Geotechnical Investigation

Proposed Mixed-Use Development
1518-1526 Stittsville Main Street
Ottawa, Ontario

Report: PG5418-1
Revision 4

Further to your request and authorization, Paterson Group (Paterson) prepared this memorandum to provide responses to the geotechnical-related comments from the City of Ottawa listed in the letter dated June 20, 2024 (File No. PC2024-0216). This memorandum should be read in conjunction with the updated Geotechnical Investigation Report (Paterson Group Report PG5418-1 Revision 3 dated July 24, 2024).

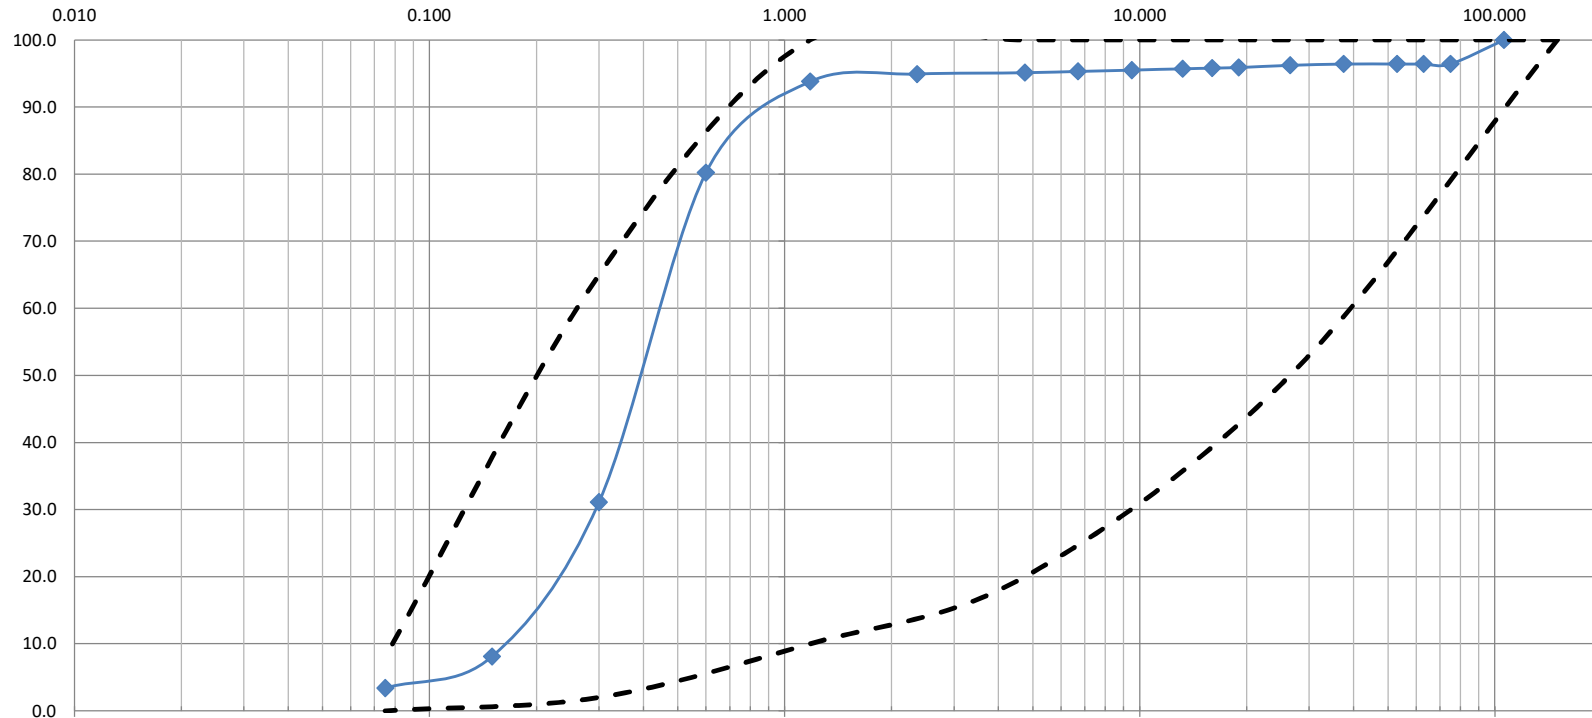
Comment 3a: *The report should discuss the results obtained for the grain size distribution test. Additionally, please confirm why only one sample has been tested for grain size distribution analysis, when the entire site is mostly made of sand.*

Response: A sub-heading has been added under Section 4.2 of the updated Geotechnical Investigation Report, referenced above, to provide and discuss the results of the grain size distribution test.
